**Addendum 1:**

CDBG-DR WATERSHED RESILIENCE & NRCS EMERGENCY WATERSHED  
PROTECTION IMPLEMENTATION PROJECT:

COAL CREEK CANYON EWP PROJECTS

January 3, 2017

**SHEET**  
 5 of 33

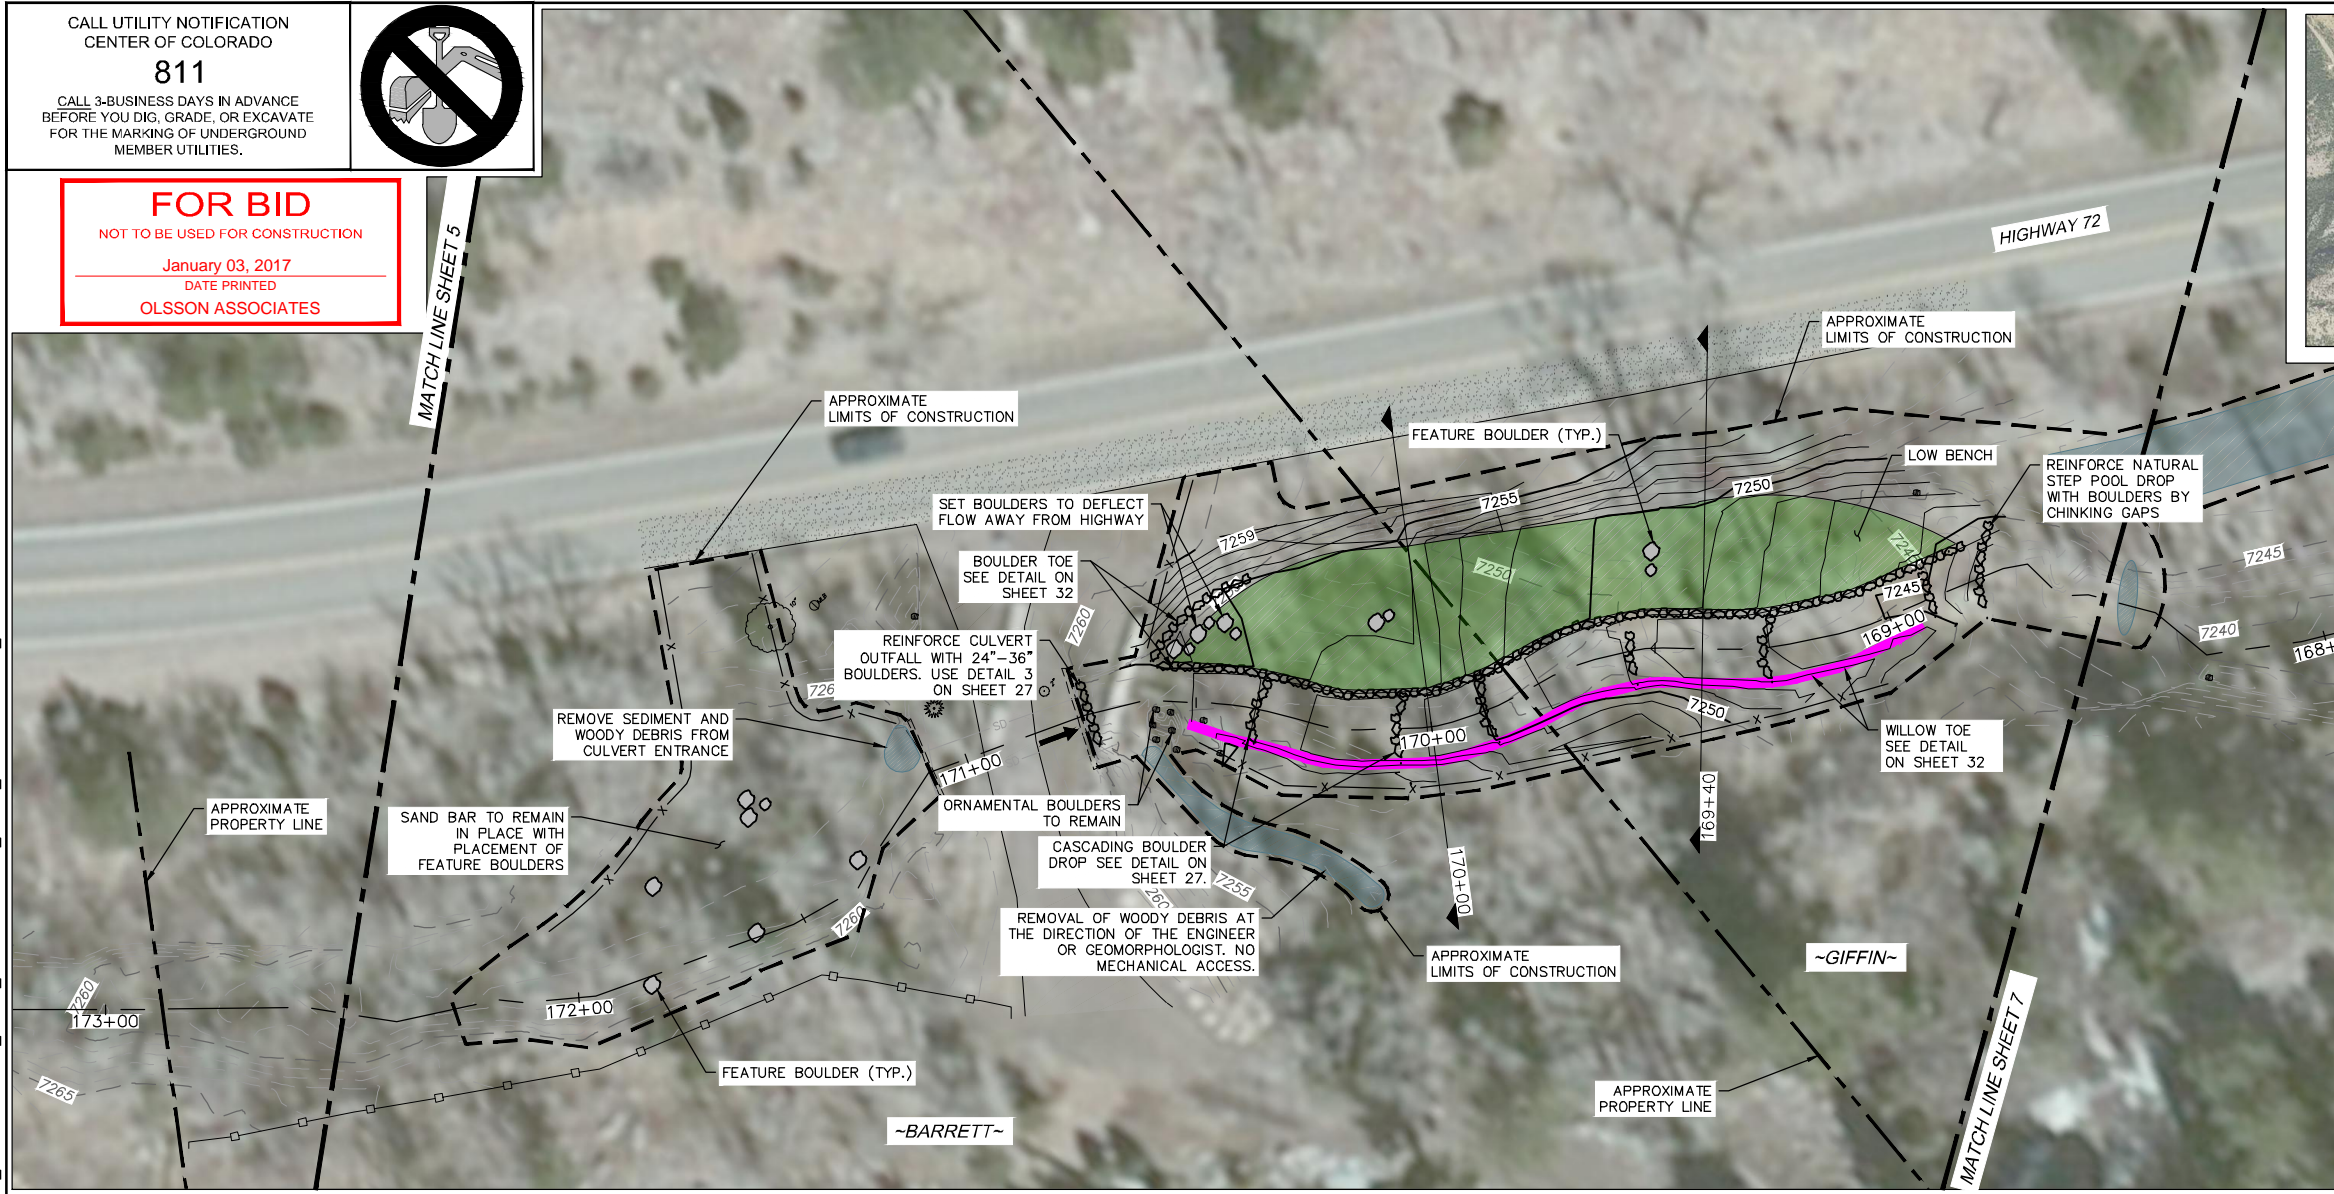
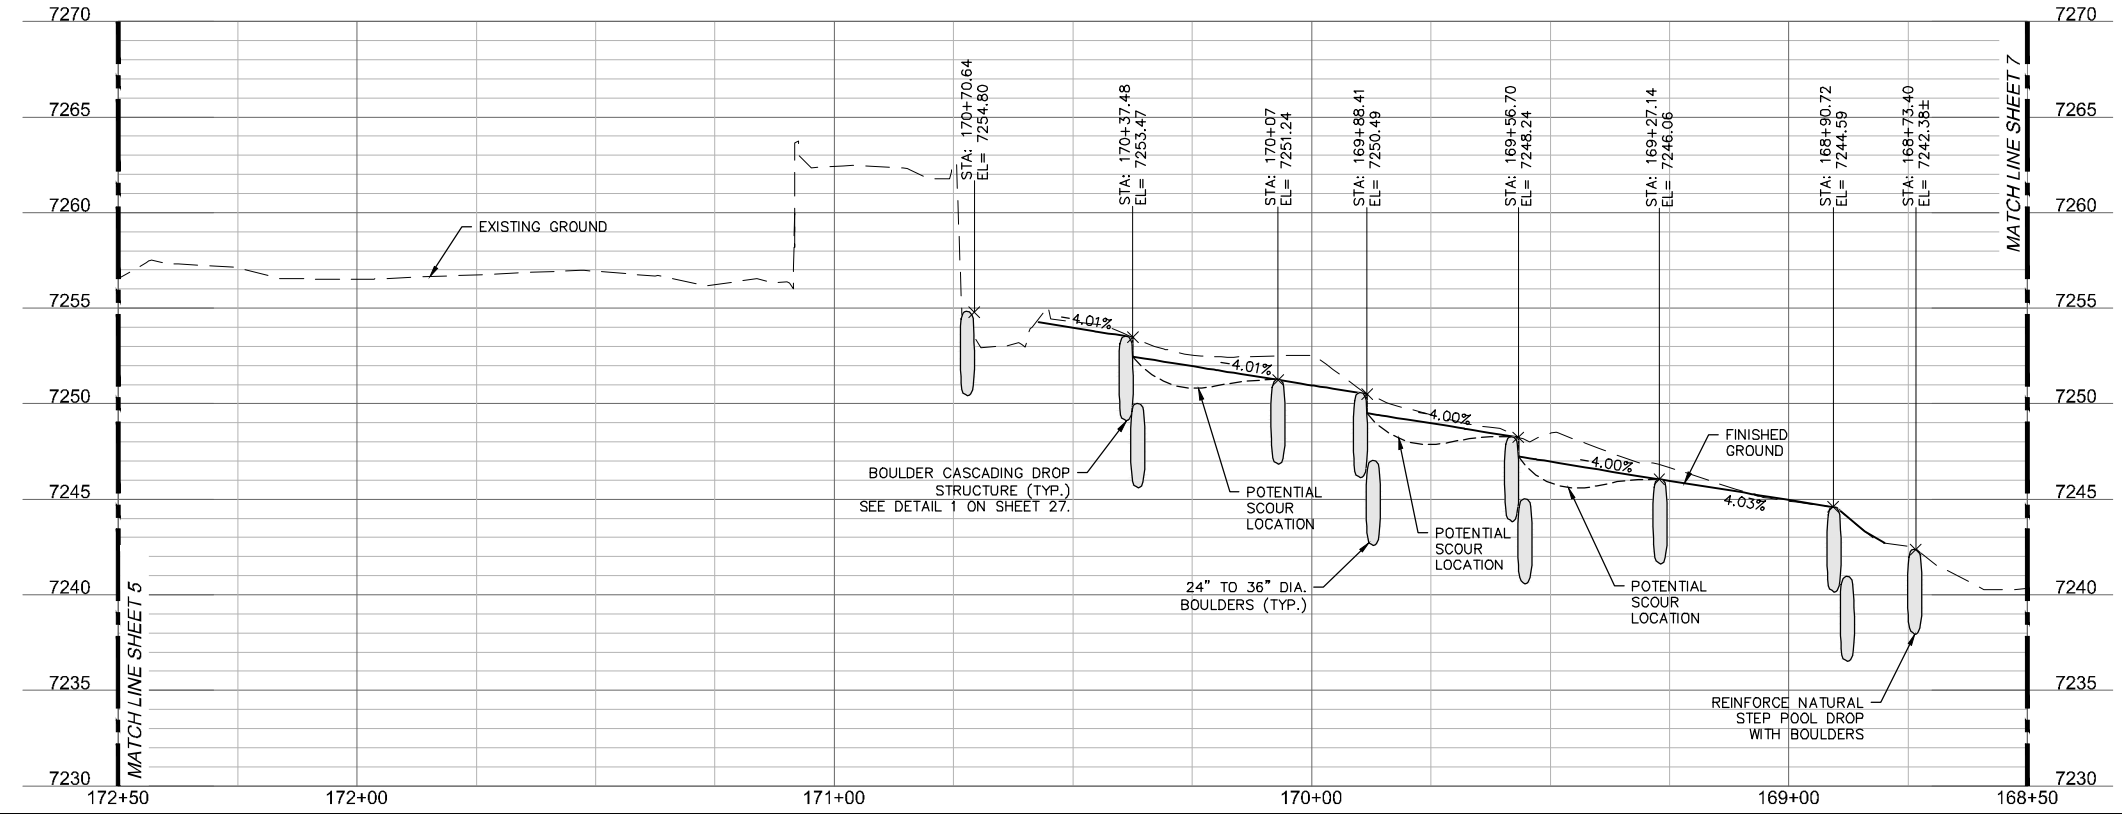
4. “Could you provide the cut/fill volumes on Sheets 3, 4, 6, 9, 10, 11 and 12? The values are not legible on the provided drawings.”

**Revised sheets are included in Addendum 1.**
